Tree value and root investigations for trees adjacent to the A3

RHS Wisley, Surrey

RHS REP10-xxx - Appendix 5 - Barrell Tree Consultancy - Report - Tree value and root investigations for trees adjacent to the A3 2 June 2020_

2nd June 2020

Figure 3: Copy of the root morphology graphic for T184 with additional annotation in blue, showing the approximate fence line, the distance of the centre of the trench to the centre of the tree being 8.5m, and the approximate trench location.

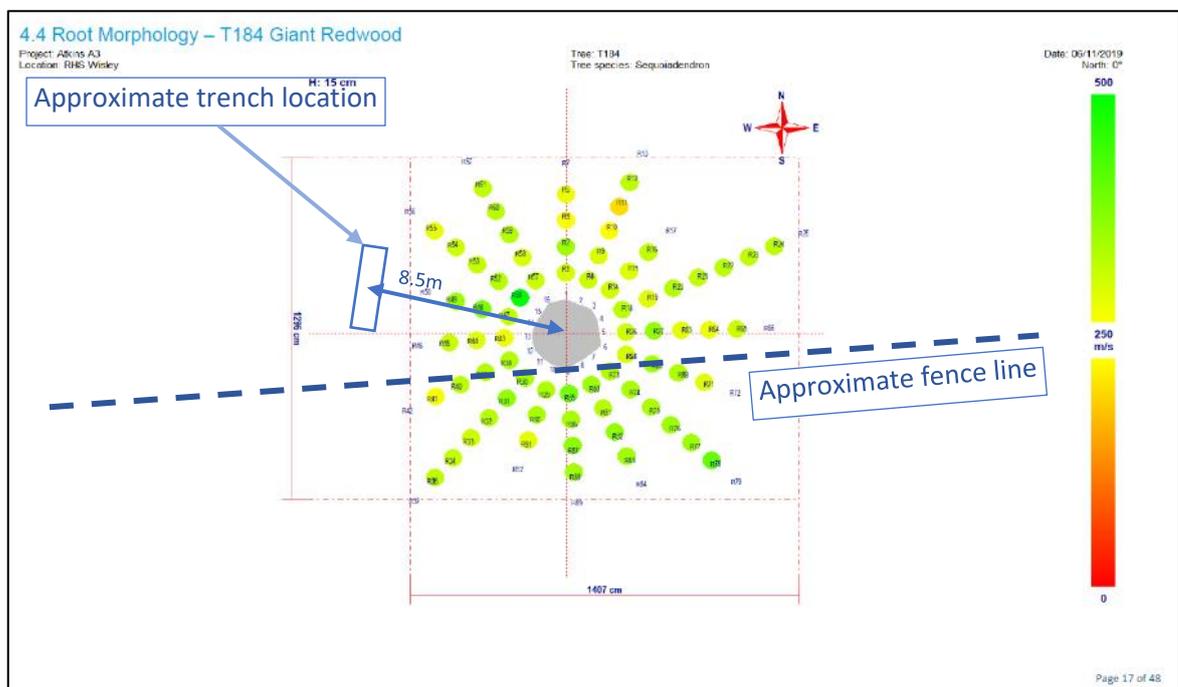
At T184, I located an area roughly to the west of the trunk, and at 8.5m from its centre, that was free from other nearby large trees (Figure 2), and excavated a trench that is approximately shown on an extract of the root morphology graphic (Figure 3). At this point, the trench was excavated perpendicular to the radius from the tree about 2m in length, 0.5m in width, and 1m depth (Figure 4). Within that trench at about 30–40cm below ground level, I uncovered three substantial roots that were measured at about 7–10cm diameter (Figure 5). I confirmed that these were alive by noting the bark was firmly attached and that they were likely to be from T184 because of the red colour of the bark and wood beneath, a known root characteristic of this species. I also noted smaller fibrous roots at the bottom of the pit at about 1m depth, that I also identified as likely to be from the subject tree (Figure 6). I did not take samples for laboratory confirmation of the species, but this could be easily done if the findings are disputed. The trench was filled in following the excavation, but it would be possible to easily open it up again if any of my observations needed to be verified.

In the absence of supporting explanations or a published record of any verification process, I decided to check the results shown on the graphic in Figure 3 by excavating in an area where the graphic indicated there would be no significant roots of greater than 2.5cm diameter. This location is shown on Figures 3 and 4, and is 8.5m from the centre of the tree, about 2.5m from the last indicated location on the graphic of any significant roots in excess of 2.5cm. The reason for choosing this location was to check the results shown in the graphic.

As can be clearly seen from Figures 4, 5, and 6, three roots of 7–10cm were uncovered, which is a size three to four times larger than the minimum size claimed to be identified by this technology. The Arboradix investigation did not identify these roots. Although I have only checked one tree, the unreliability of the data was so startling that it must throw into significant doubt the data for the rest of the trees. This simple investigation has confirmed that the results shown in this graphic, and possibly all the other graphics, are not reliable and cannot be credibly used as the basis for advising on any adverse impact on any of the trees without further investigations.
